Based on the considerations presented in this report, my view is that a food truck can satisfactorily operate out of the compound of 121 High Street, Campbell Town, without impacting the operation of the existing shop and without impacting on traffic along the frontage road.

Planning Application PLN-21-0315- Additional Information Required for Change of Use to Food Services, Signage, Food Van (Heritage Precinct, Signs Code, Road & Railways Code) at 121 High Street, Campbell Town

I would like to make some comments regarding the application.
There are 4 pictures for reference.

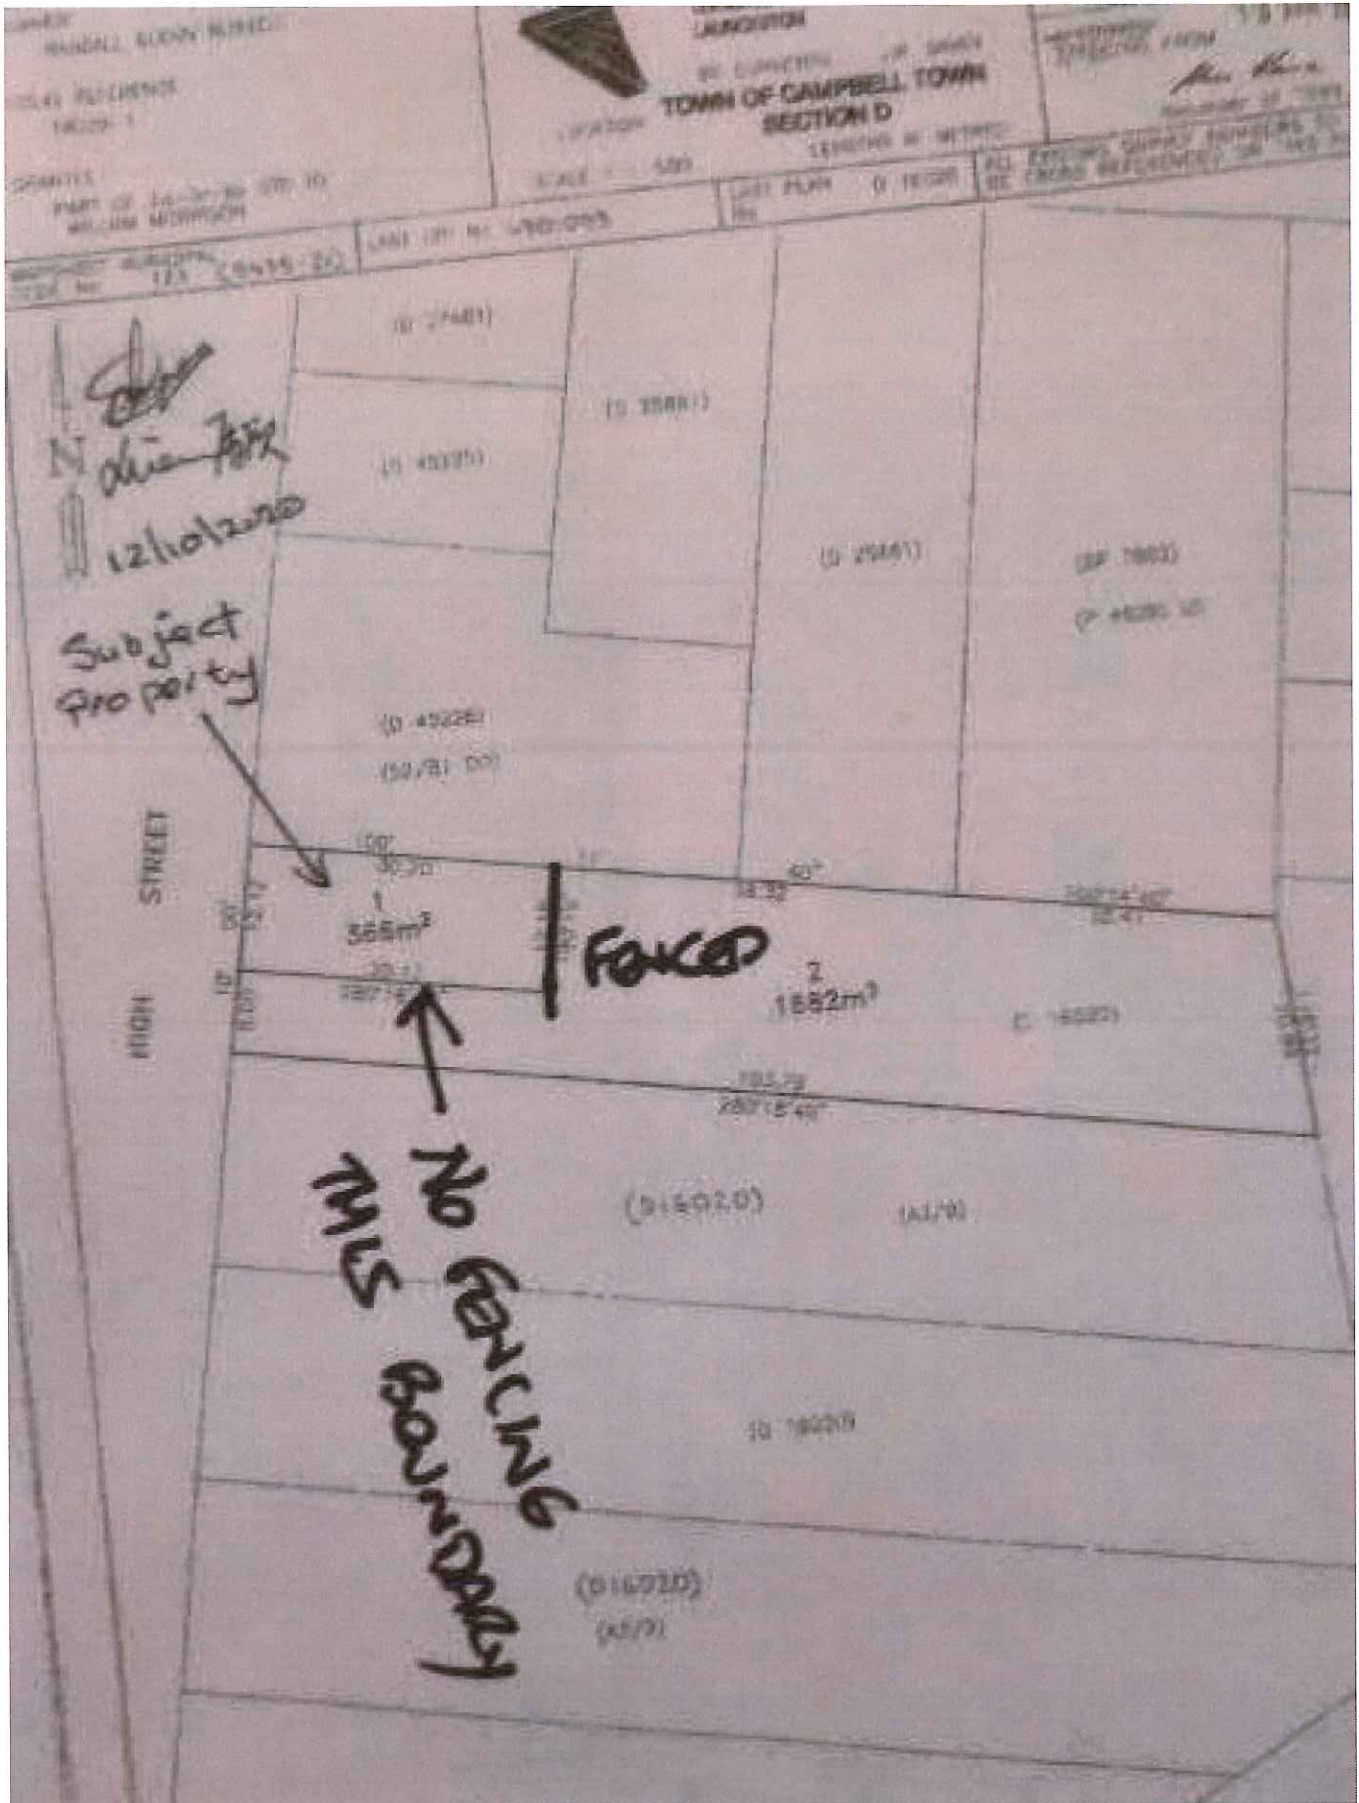
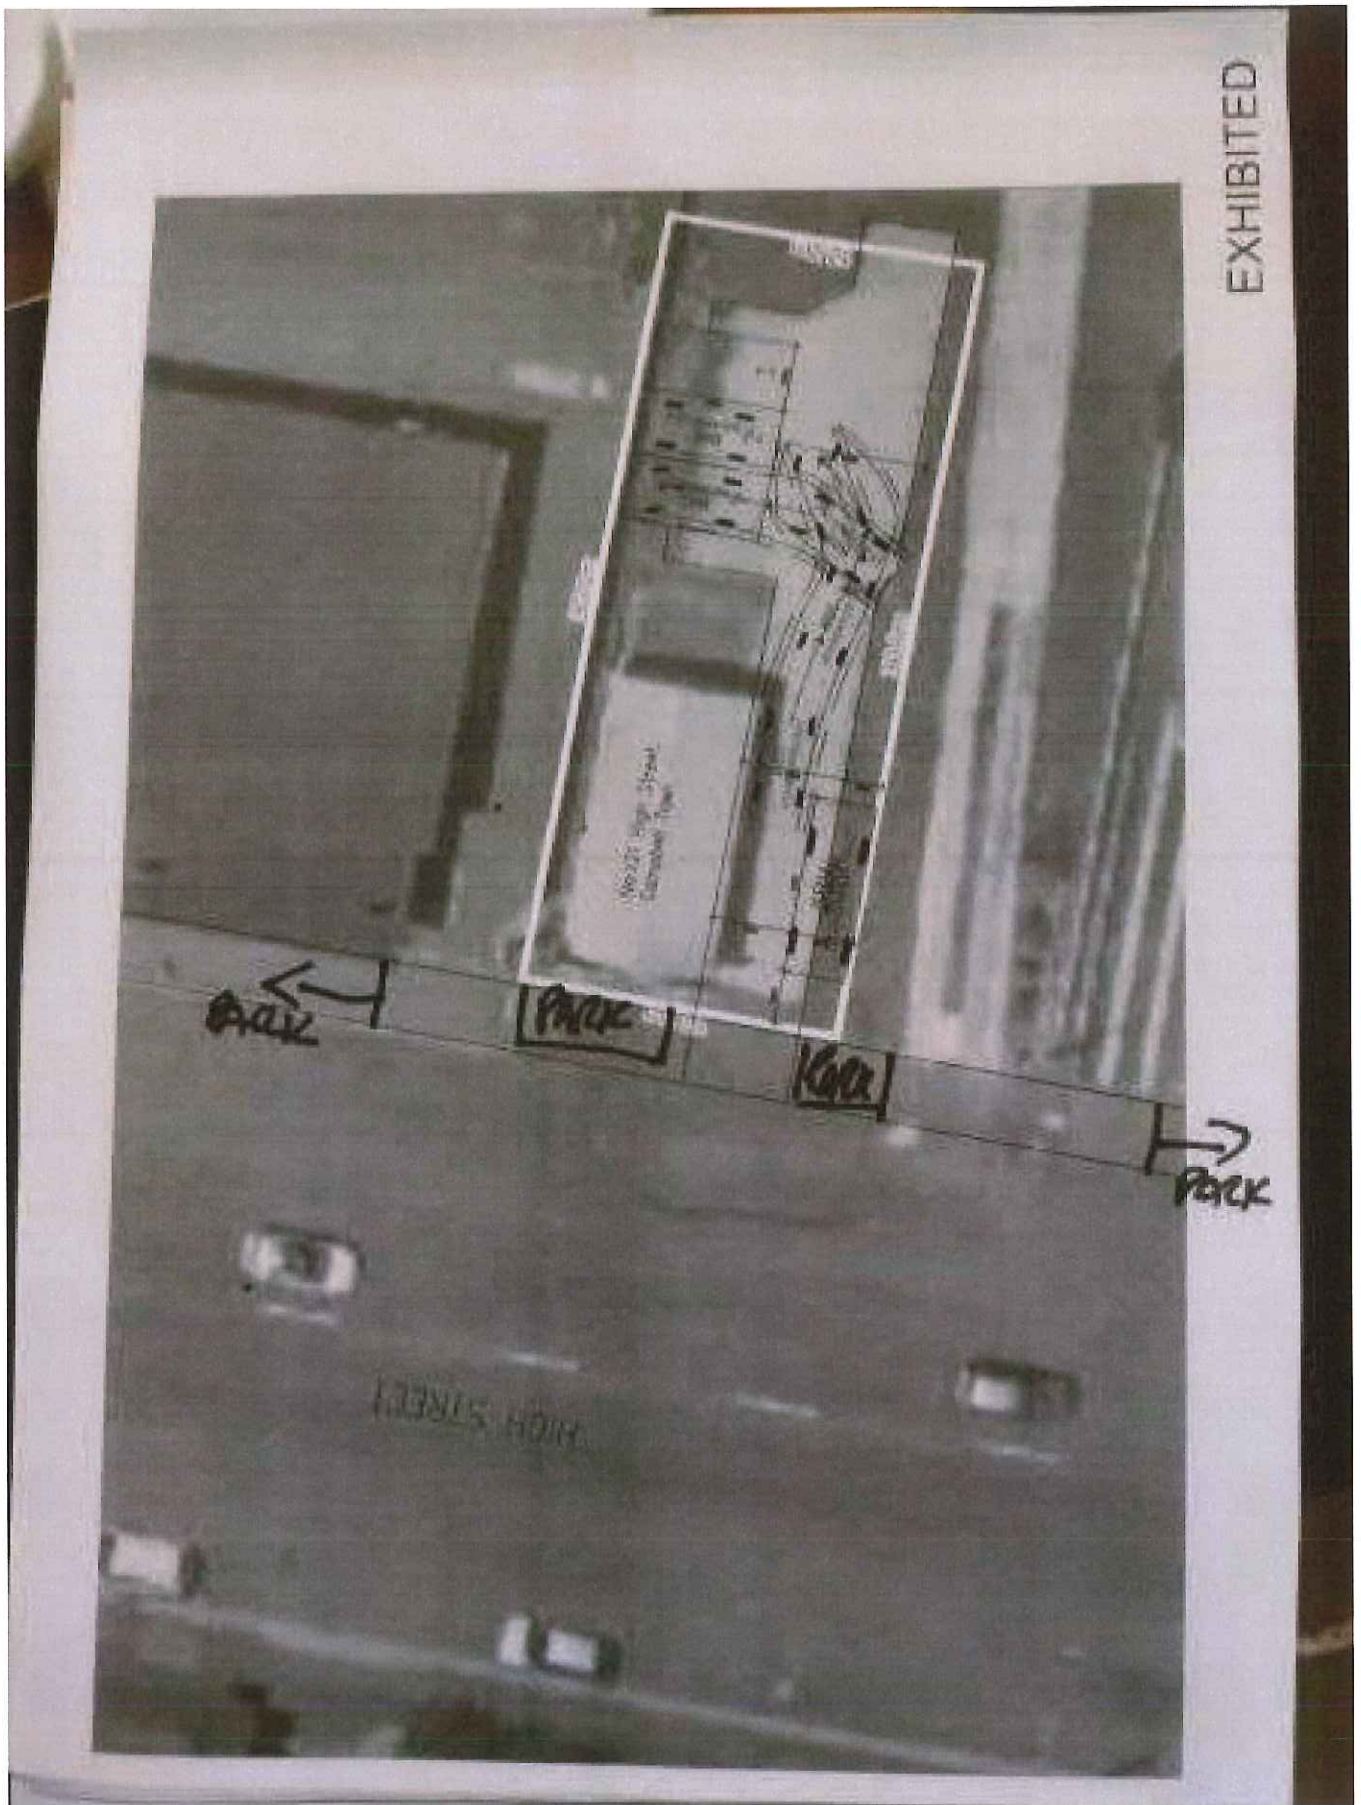
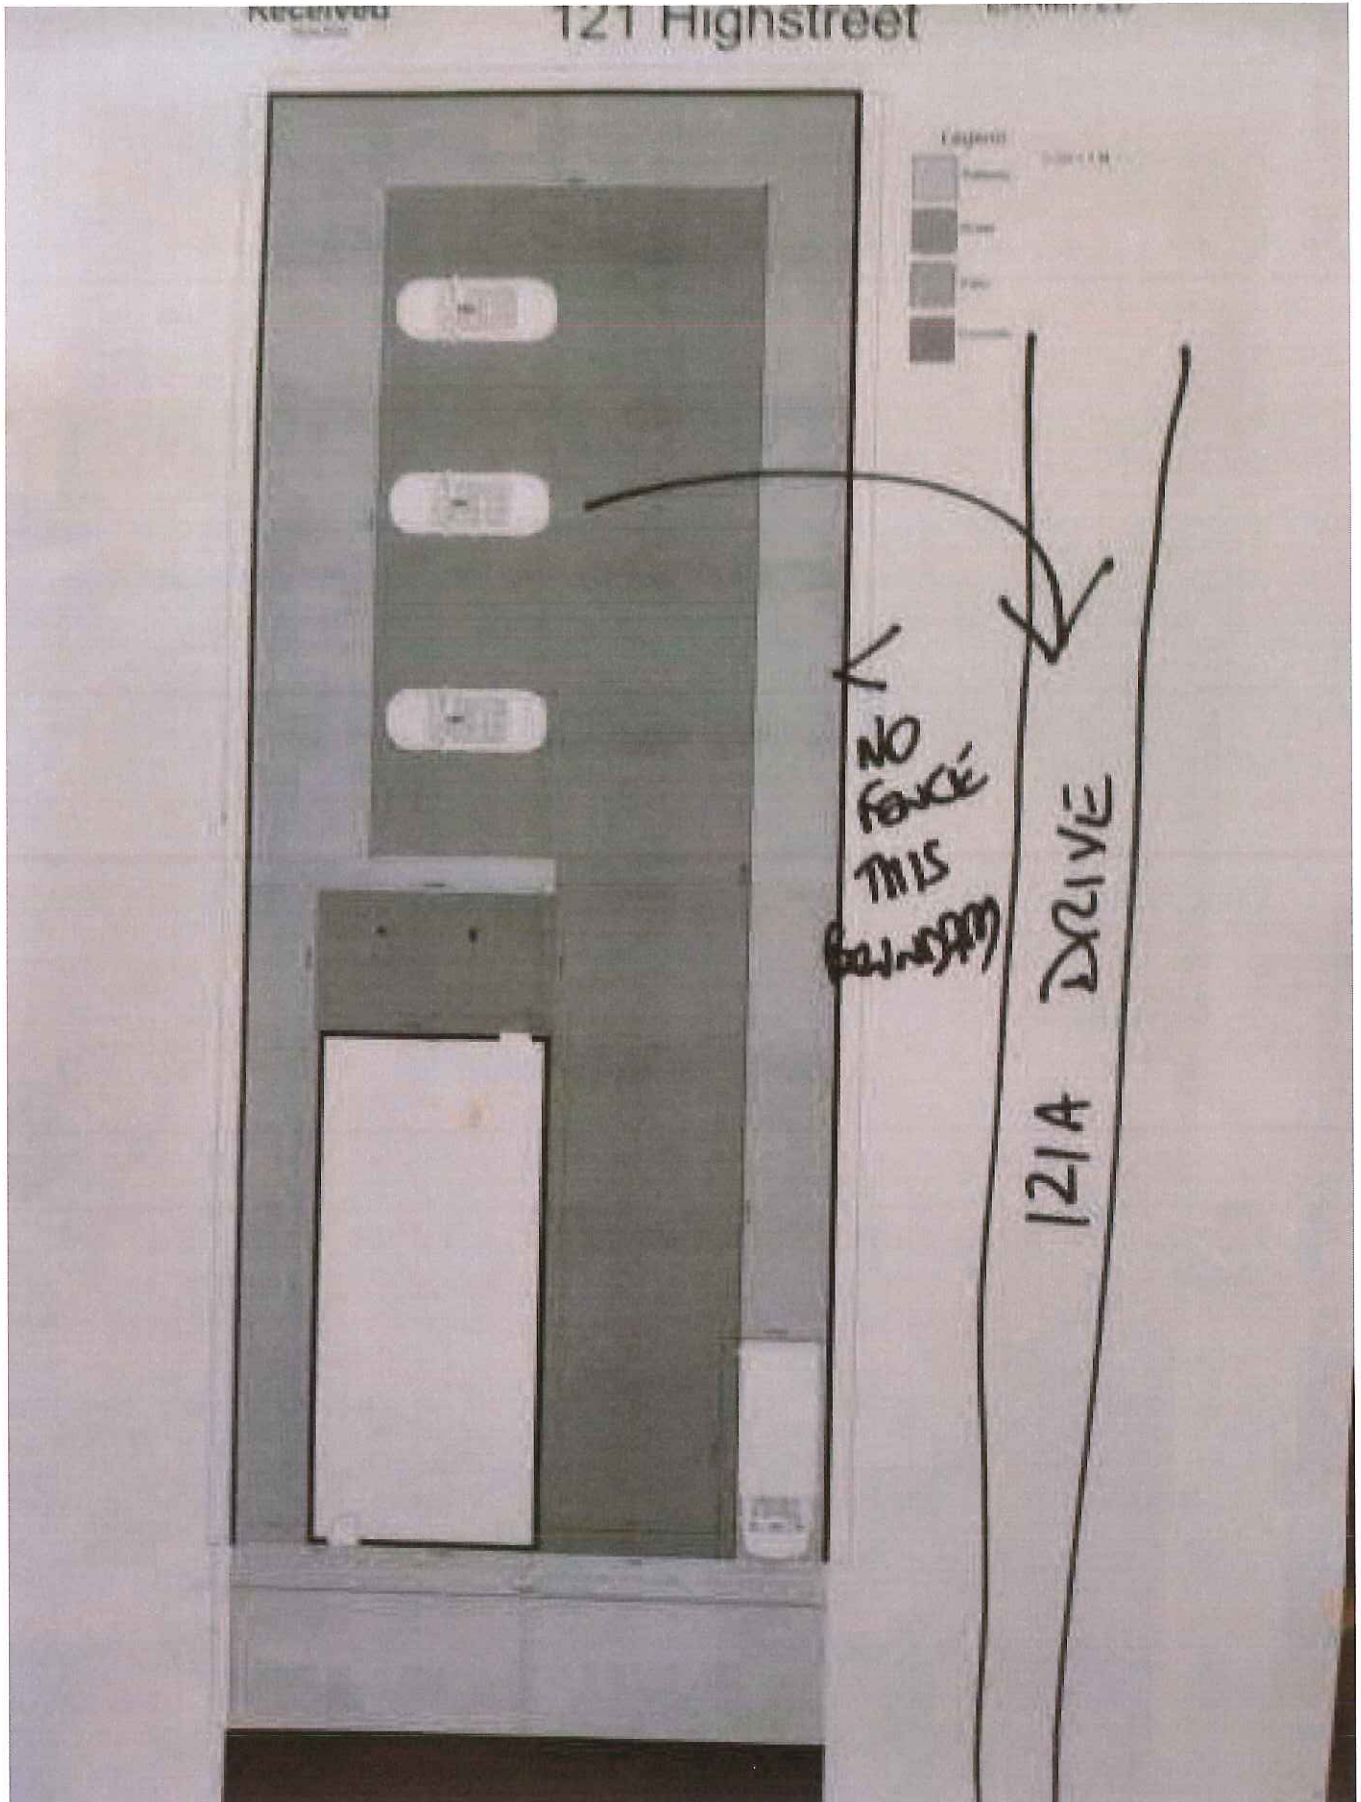
1. On pic 3 I have noted that there is no barrier or fencing between my property/driveway and the proposed development.
Will the staff entering and exiting the van need to encroach beyond the boundary to utilise the van? The van entrance/exit is not defined.

2. I have looked at the traffic management plan and can see a problem, the plan explains what happens in a perfect situation. Should there be 1 car trying to enter and 1 or a number of patrons at the front of the van, the easy way to exit the property would be to cross the grass verge between properties and use my drive. Pic 4
As you see there is no boundary definition.

3. I have noted on Pic 2 the roadside parking, my fear here is that anyone parking to the South will decide to use my drive to walk around the van especially if there is traffic entering or exiting.

4. I note that power will be sourced from existing building. How will this be done, by cable laid across driveway? I also note there is no mention of water, how will this be supplied?
I assume water will be required for cleaning and hand washing ect?
How will waste be disposed of, Pic 1 shows the slope where the van will be parked, and also the lack of definition of the block. It would be very easy to allow water to escape the van onto the grass and food pieces left would be a magnet for vermin.
